## **Transport Assessment**

08 March 2024

Service Request No: 517439

**Site Address:** 26 Ganges Road, 3 Dekka Street, 31-33 Nicholson Road, Khandallah

Figure 3.3.1: Collision diagram from last ten years crashes.

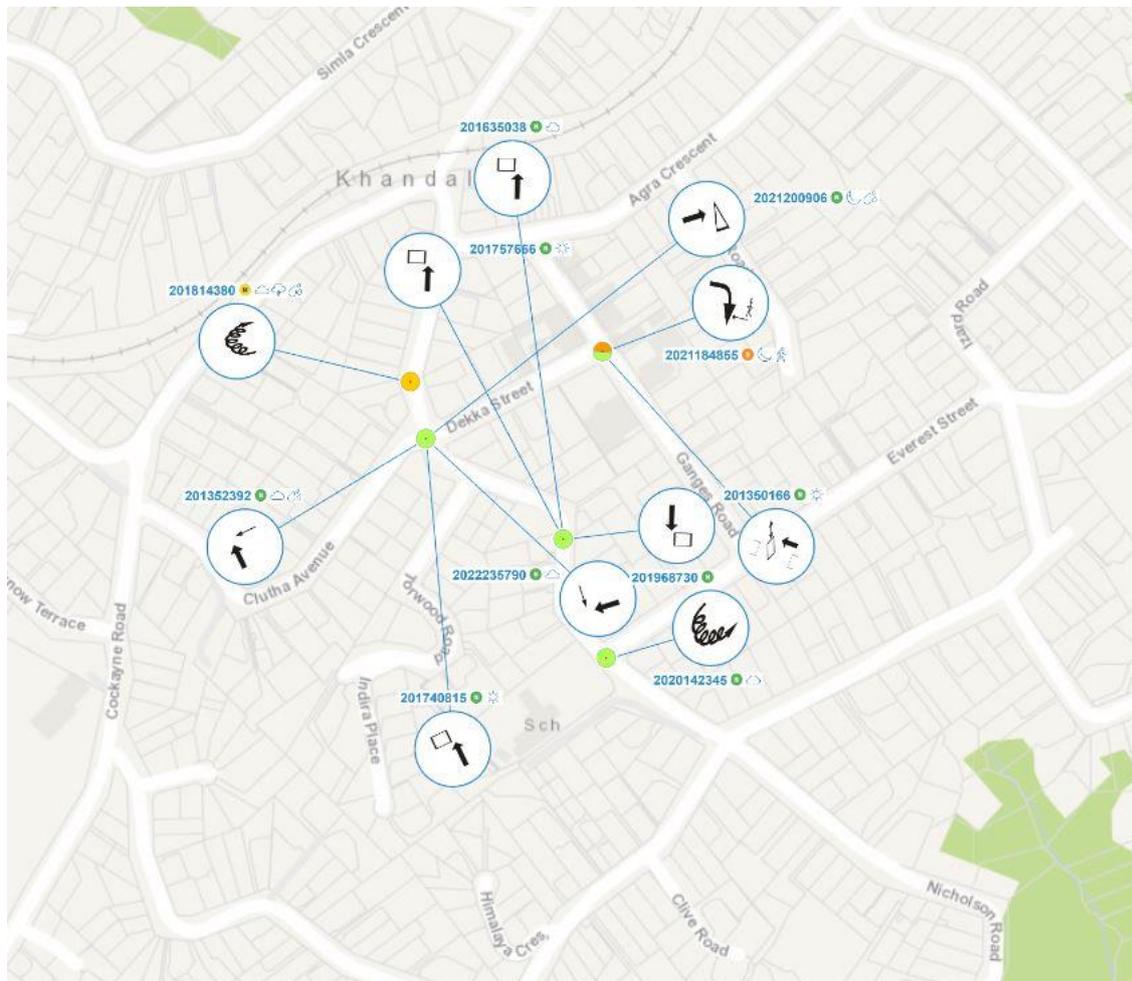
1. Nicholson Road: five midblock crashes noted.
  - a. The concern section shows two loss of control, and three involving parked vehicle crashes which indicates speed is a concern along this section.
  - b. Three parked vehicles also indicate that approach speed is not appropriate for the environment.

Out of five crashes four crashes are non-injury crashes and one of the loss control crashes is minor injury for the 300m long section for the last ten years. No Safety work is necessary with the current situation. This situation will change if a proposed driveway with higher traffic volume than present driveway.

By considering the ten-year data for all these concern sections of roads are operating safe except the 300m section noted above with the proposed driveway.

This 300m section of Nicholson Road increases the risk further when introducing a proposed driveway intersection in this section. There are pedestrians, which includes school children walking along the section of Nicholson Road and the proposed driveway expected to increase number of turning vehicle at this location. In addition, all the arms of this proposed intersection are in slope and a curve (the Northern approach to the corner with the proposed entrance is on a downhill approach around a blind bend). By considering all the above we must have a risk mitigation measure. That is a raised safety platform at the intersection of Nicholson Road and the proposed driveway to New World is as a suggested condition. This raised safety platform includes clear marking of pedestrian crossing. This suggested raised platform with pedestrian crossing reduce the safety risk from the following:

- The expected vehicle approach speed in all the arm will be reduced.
- Plenty of sight line available for the reduced speed
- The safety of pedestrian will be increased.

1. Provide a raised safety platform at the proposed intersection of the new driveway and Nicholson Road to mitigate the safety risk and minimise the turning traffic queue.
2. Provide additional cycle park to promote cycle users and minimise peak hour vehicular traffic and the delay.
